December 2021
FL905A
NHTSA #21V-864
Transport Canada #2021-681

Subject: Western Star 49X Steering Pinch Bolt

Models Affected: Specific model years 2021-2022 Western Star 49X model vehicles manufactured June 17, 2020, through October 19, 2021.

Fig. 1, I-shaft Installed Properly

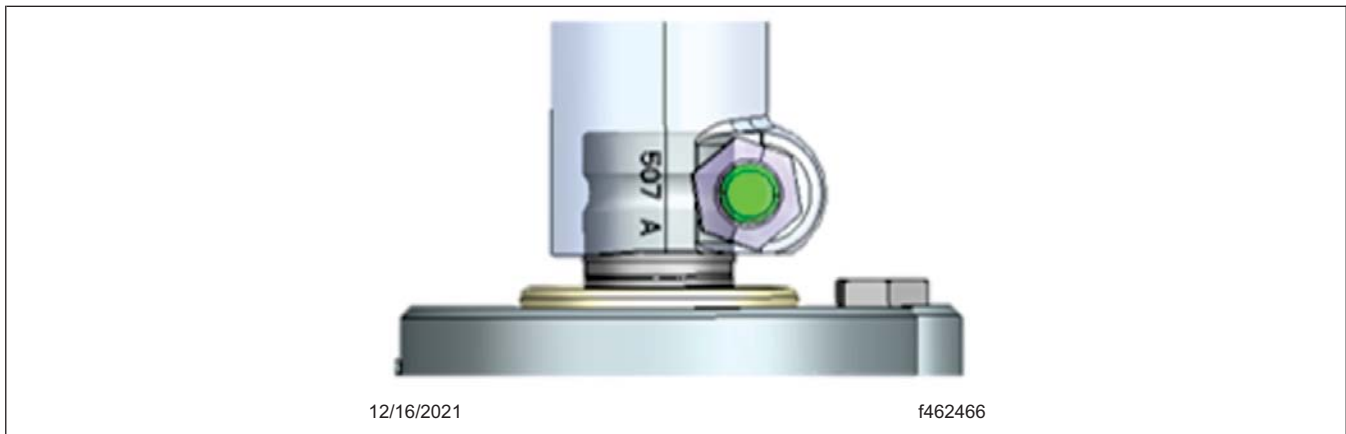
1. Park the vehicle on a level surface with the front tires pointed straight ahead. Shut down the engine, set the parking brake, and chock the tires.
2. Open the hood.
3. With the truck running, turn the wheel so the pinch bolt is accessible at the top of the steering shaft.
4. Inspect the I-shaft to ensure it is seated all the way down to the steering gear. For correct installation, see [Fig. 1](#). For incorrect installation, see [Fig. 2](#).

If installed properly, no further action is required. Proceed to the step 5.

Fig. 2, I-shaft is Lifted or Displaced

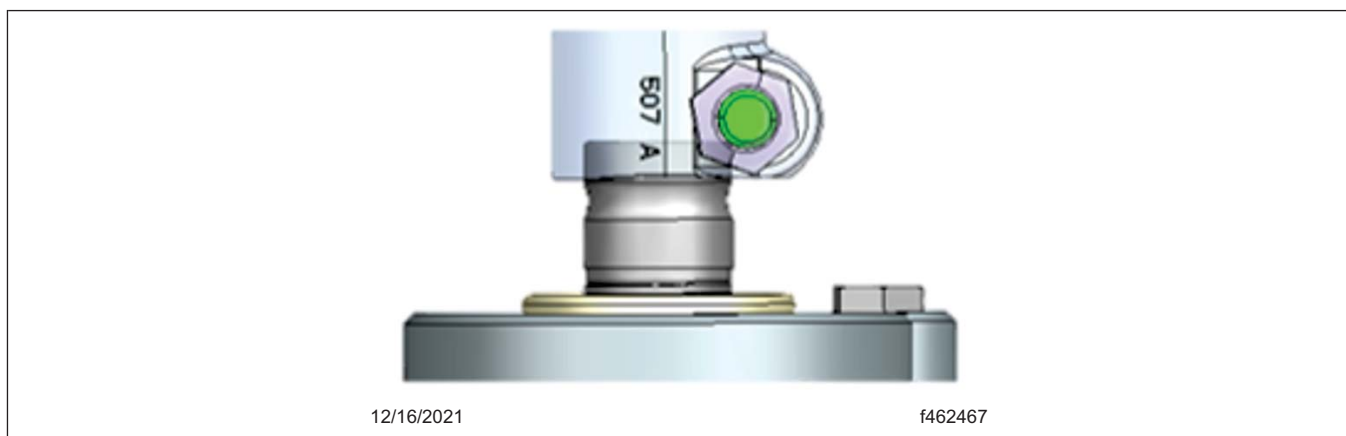
If lifted and not seated correctly, go to the Pinch Bolt Replacement procedure below.

NOTICE: Do not remove the steering shaft from the steering gear, it is only necessary to slide it the rest of the way on the steering gear until seated completely. Removal of the I-shaft could result in the steering wheel being rotated and damaging the clock spring. Once seated and the new pinch bolt is installed, torque the nut on the pinch bolt until required torque is achieved.

1. Remove and discard the pinch bolt and nut on the gearside of the I-shaft.
2. Slide the steering shaft down so it is flush with the steering gear.
3. Install the new pinch bolt and nut.
4. Tighten the pinch bolt 30 to 35 lbf·ft (41 to 47 N·m).
5. Use blue torque seal after the required torque has been set.
6. Clean a spot on the base label (Form WAR259), write the recall number, FL905, on a blank red completion sticker (Form WAR260), and attach it to the base label, indicating this work has been completed.
